Beaches Link and Gore Hill Freeway Connection

Environmental Impact Statement
(EIS)

Artarmon

Operational noise

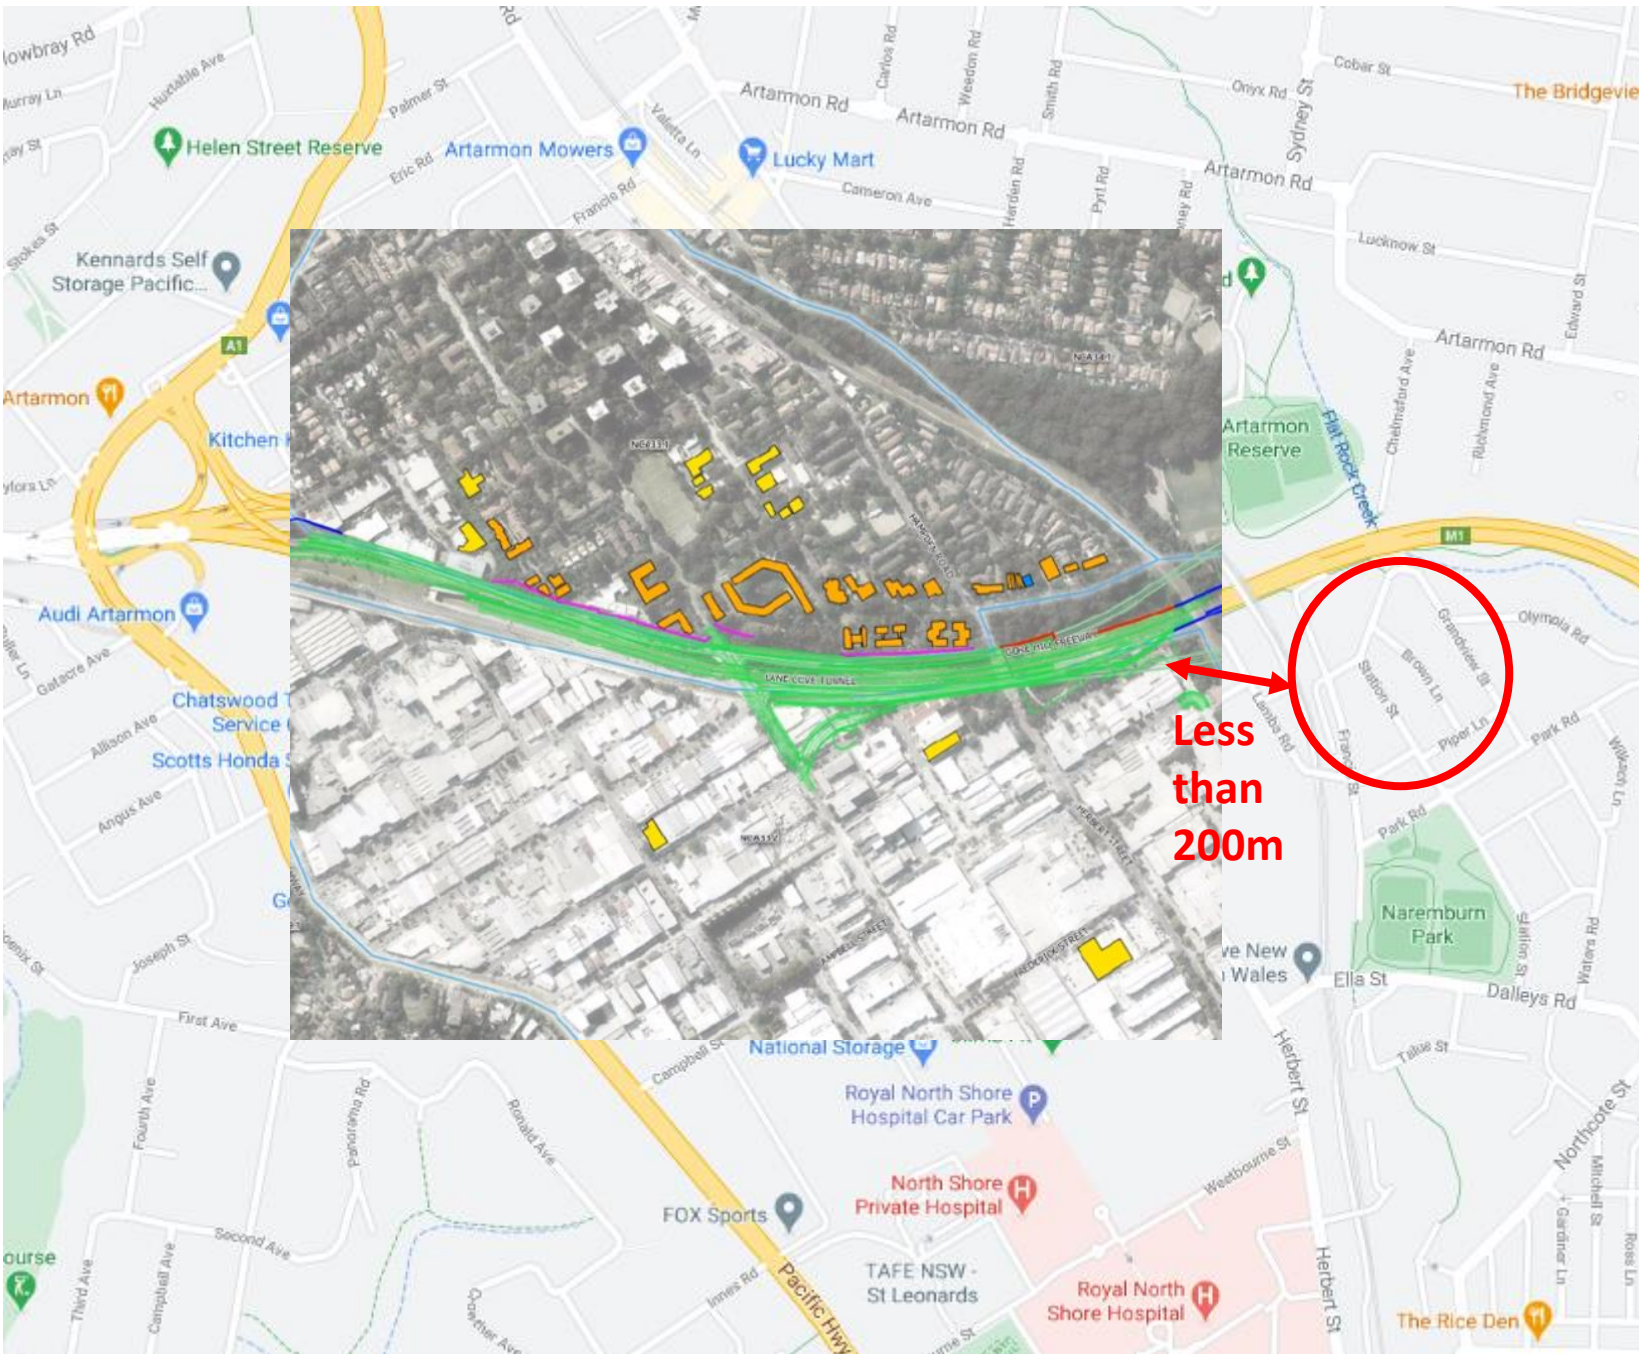
ISSUE:

The Naremburn residential area (NCA32.1) located less than 200m from the major construction zone has not been considered at all for at-property treatment .

ASK:

That the Naremburn residential area (NCA32.1) be made eligible for at-property noise reduction treatment

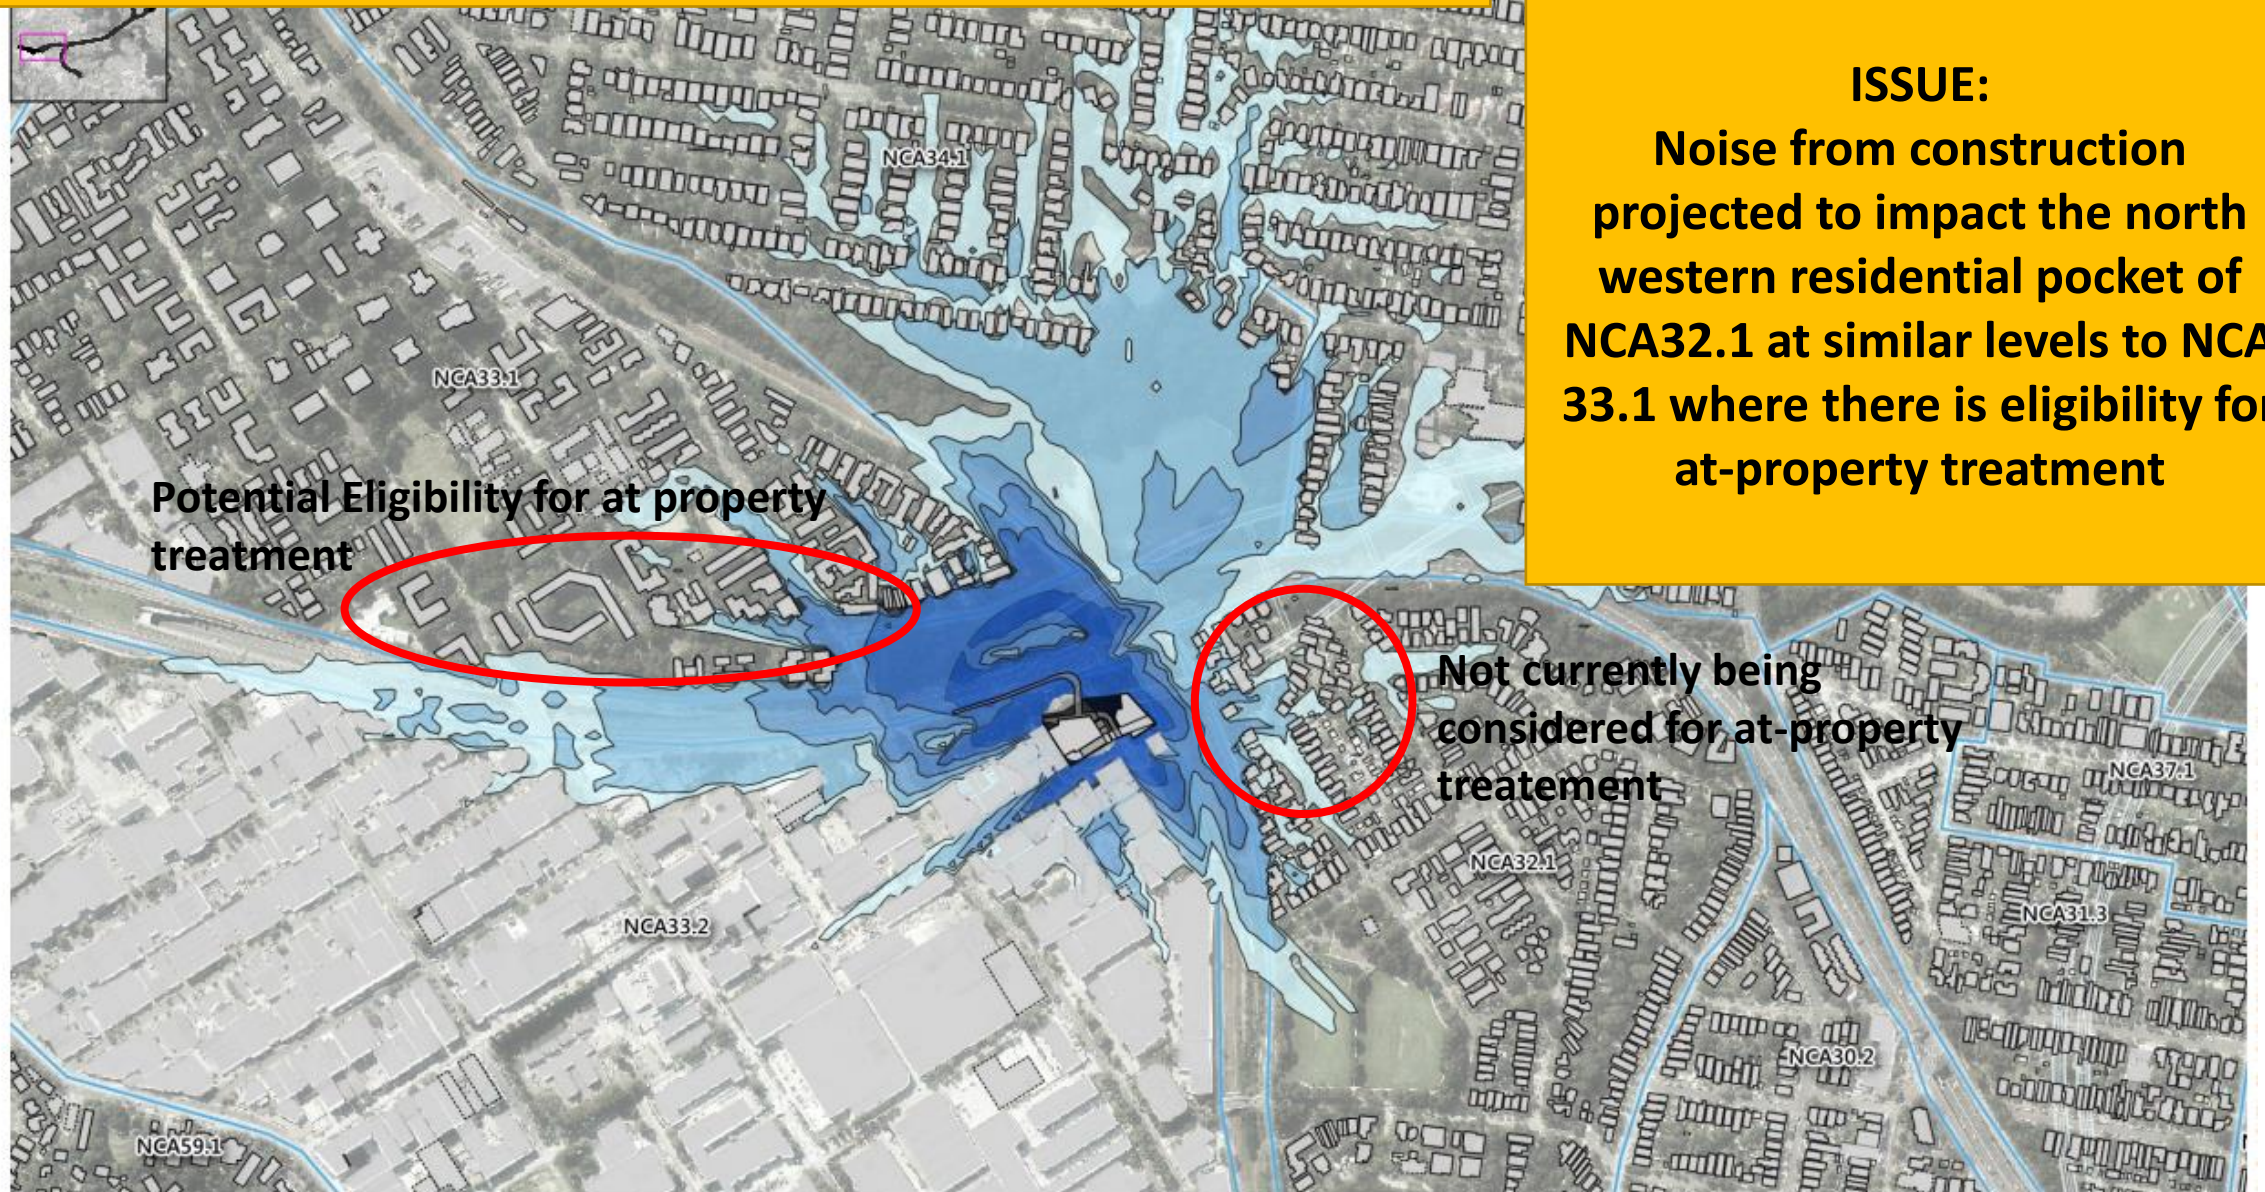
ISSUE:

Noise from construction projected to impact the north western residential pocket of NCA32.1 at similar levels to NCA 33.1 where there is eligibility for at-property treatment

From Chapter 10 of the EIS

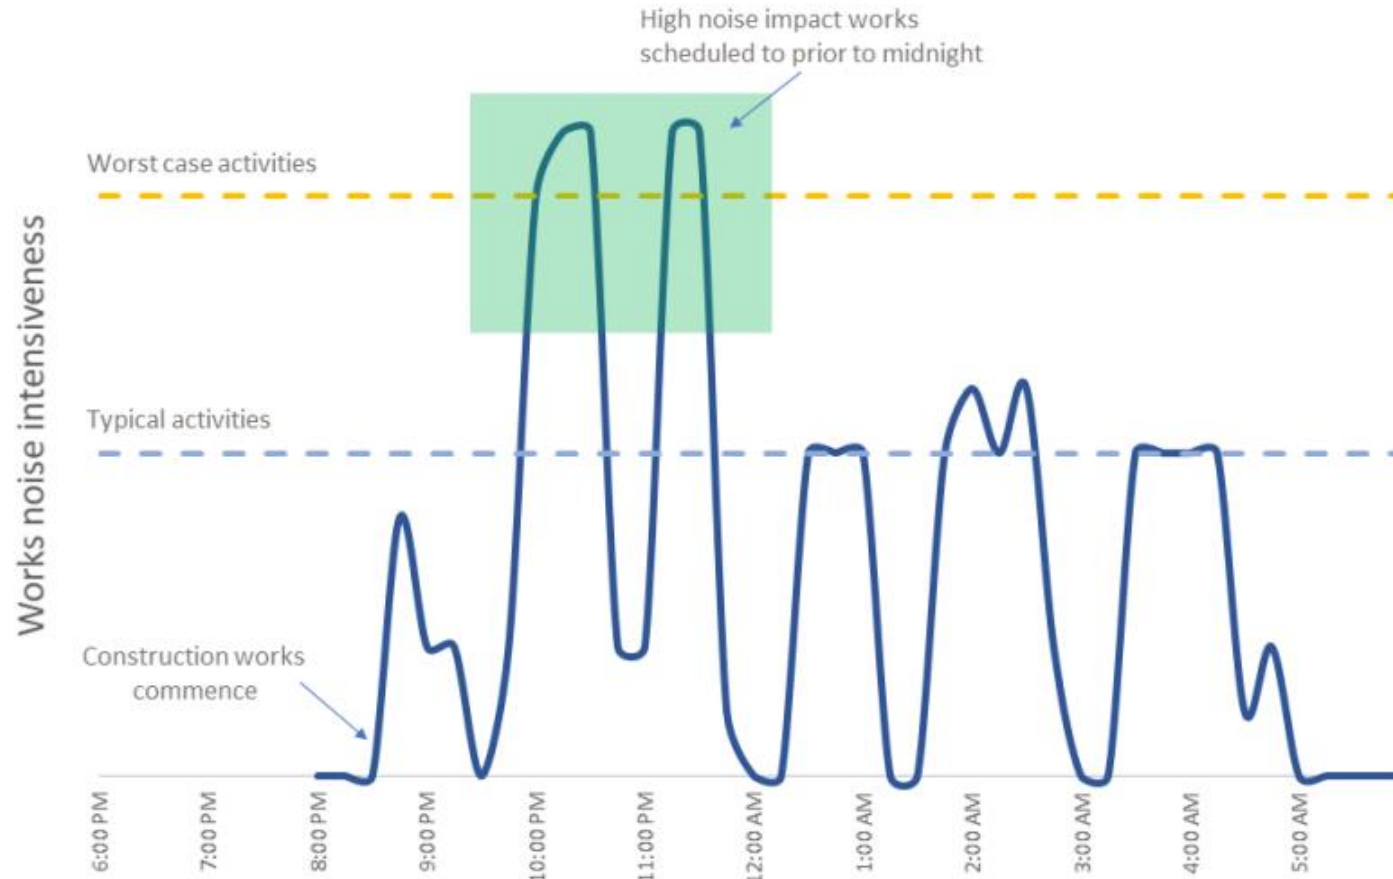
ISSUE:

High noise activities are planned to be from 10:30pm to midnight

This will severely impact the ability for families to commence sleep each night resulting in sleep deprivation, a key contributor to mental health issues

ASK:

Any high-noise activity be completed during daylight hours
